VILLAGE OF THIENSVILLE
Plan Commission
AGENDA

DATE: Tuesday, November 9, 2021
LOCATION: 250 Elm Street, Thiensville, WI
TIME: 6:00 PM

C. Review and action regarding Architectural Update to Approved Cheel project, 105 S. Main Street

UPDATE TO CHEEL RESTAURANT PLANS

SHEET:
A-1

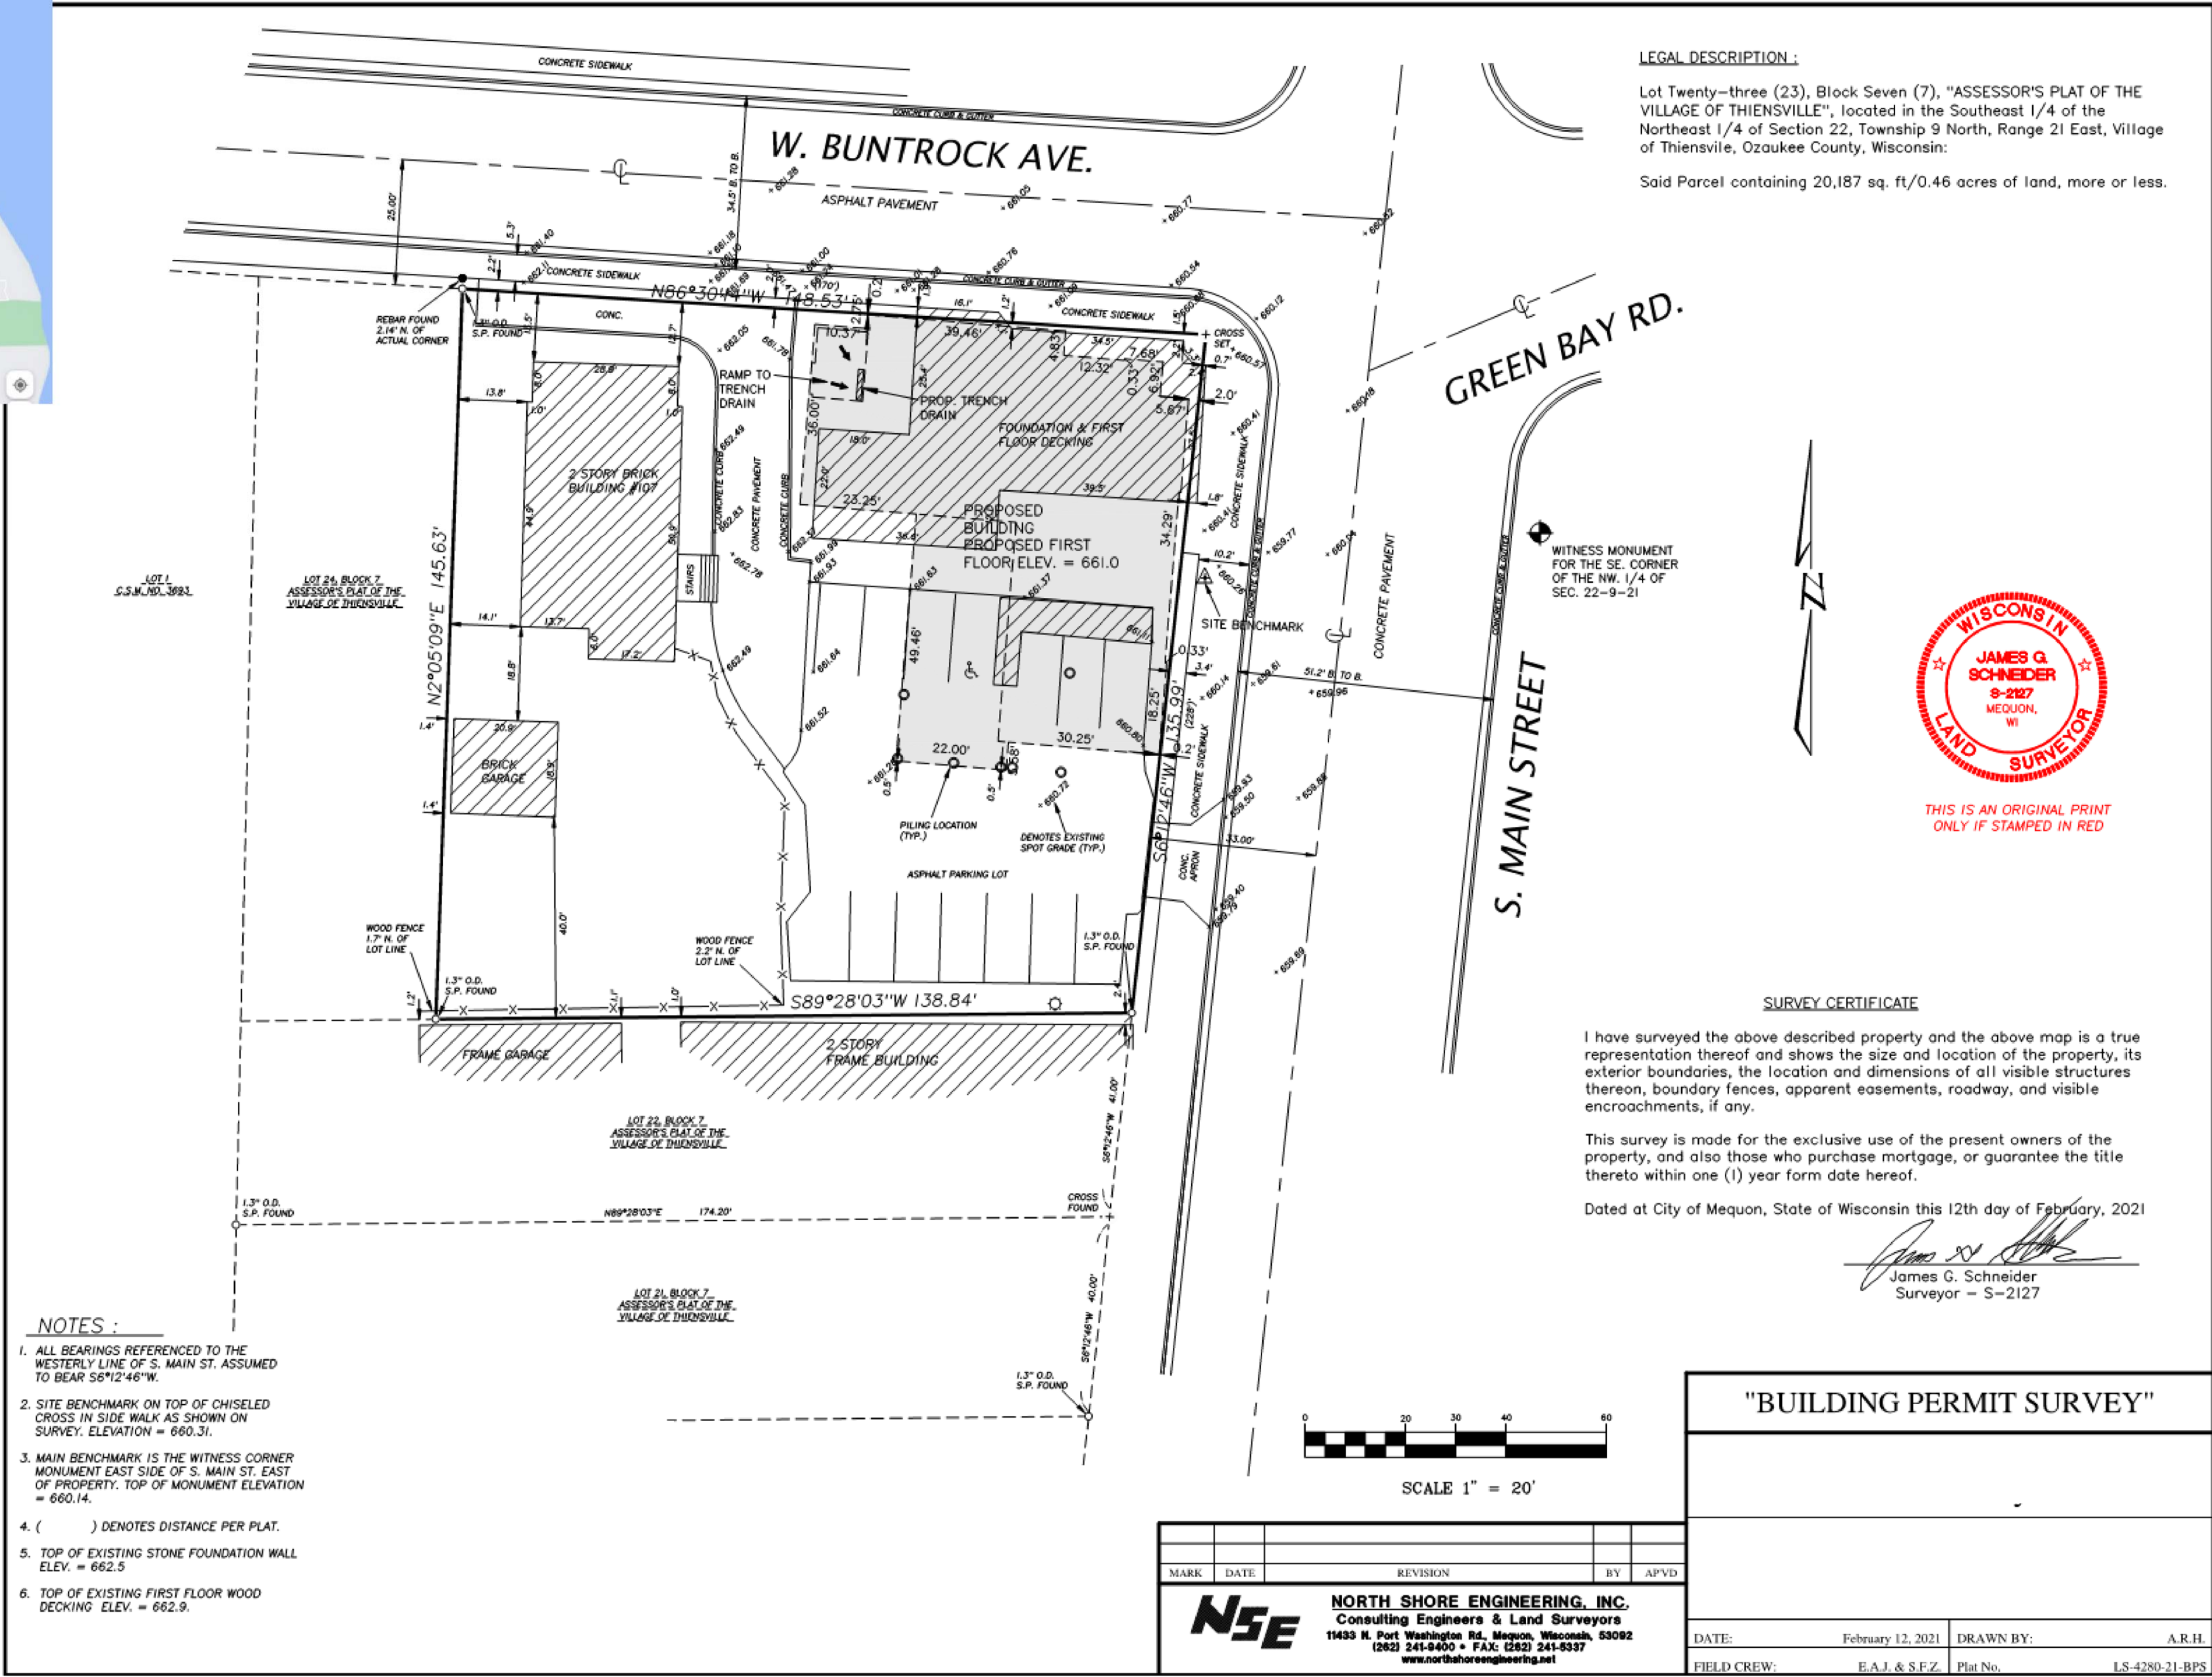
- The building footprint and size has been reduced and is now 3,600 square feet smaller.
- The building setback from the Buntrock Road right-of-way has been increased from 0 to 12 feet which will improve safety and visibility at that intersection and provide the Village the ability to improve the design of the intersection in the future if needed.
- The size of the patio has been reduced by 300 square feet.
- The width of the exit drive has increased.
- As a result of the reduced building size, the code requires 14 fewer parking stalls.

Staff support this plan update as it reduces the impact at this location, requires less parking, and improves the intersection vision corner providing for a safer environment. Accordingly, staff recommends approval.

A-4

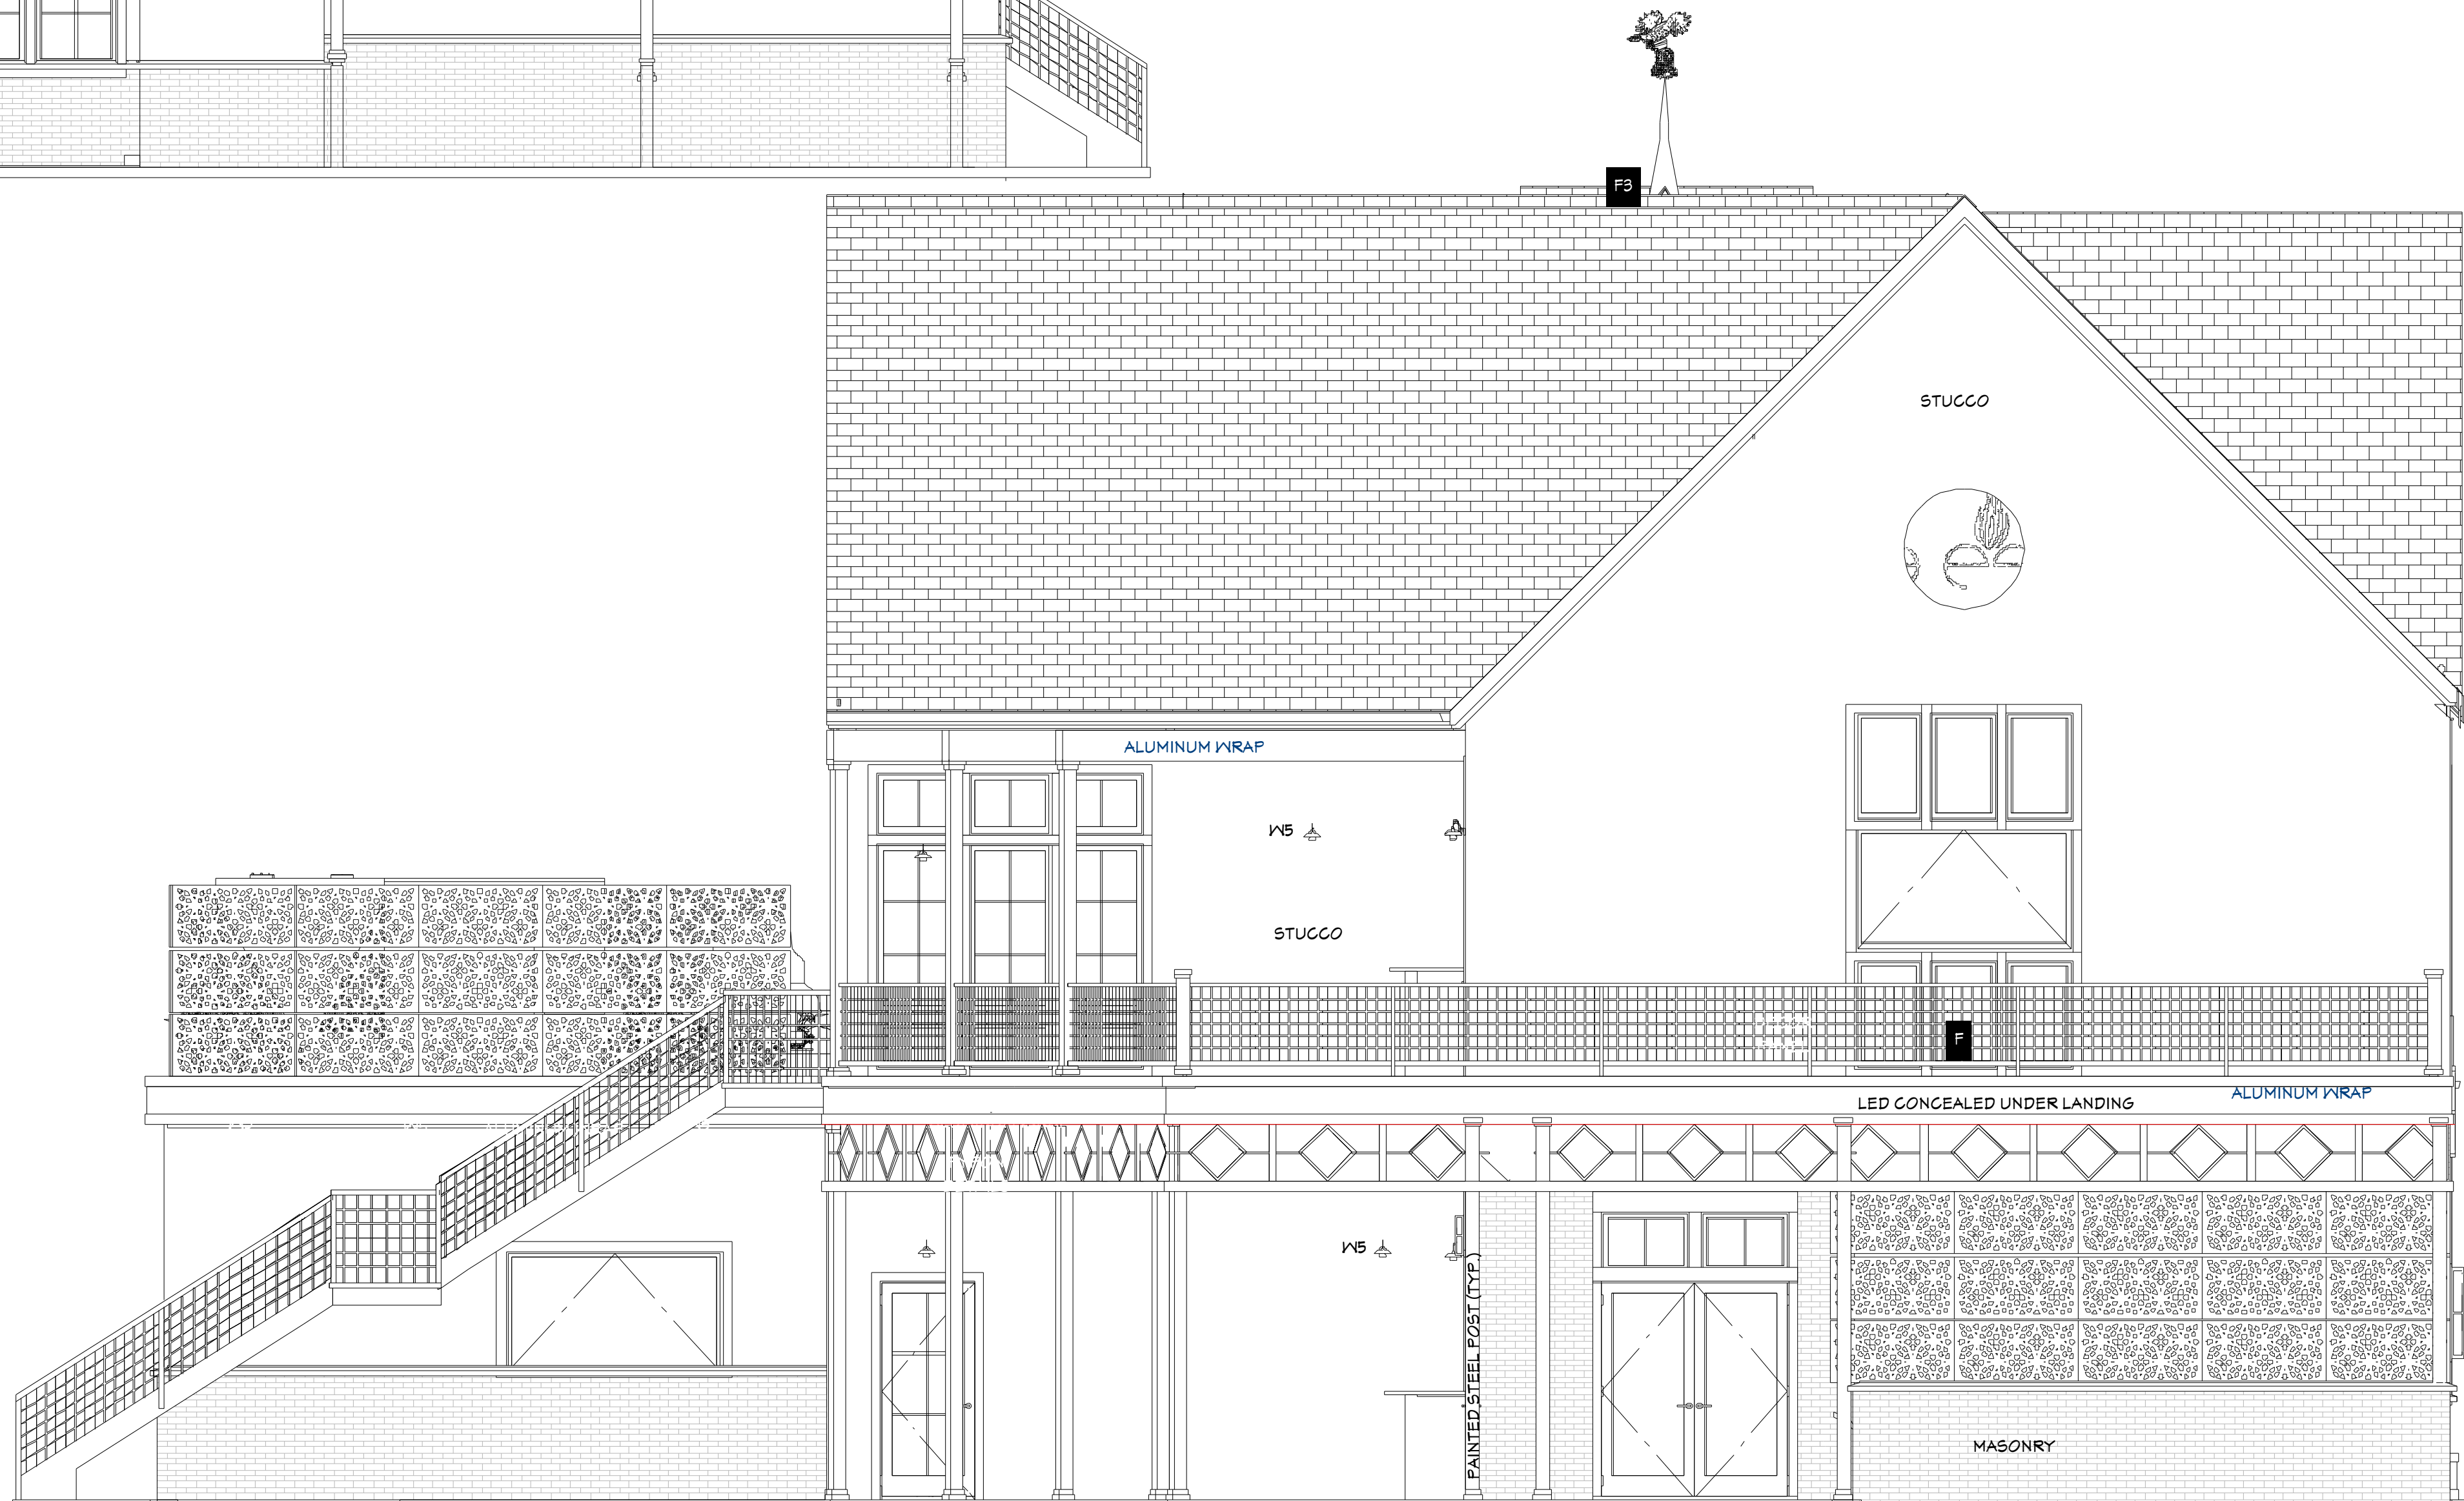
While the general building design and use of materials remain unchanged, there is a slight modification to the north elevation with one less gable roof and the tower is shifted further to the west than previously approved.
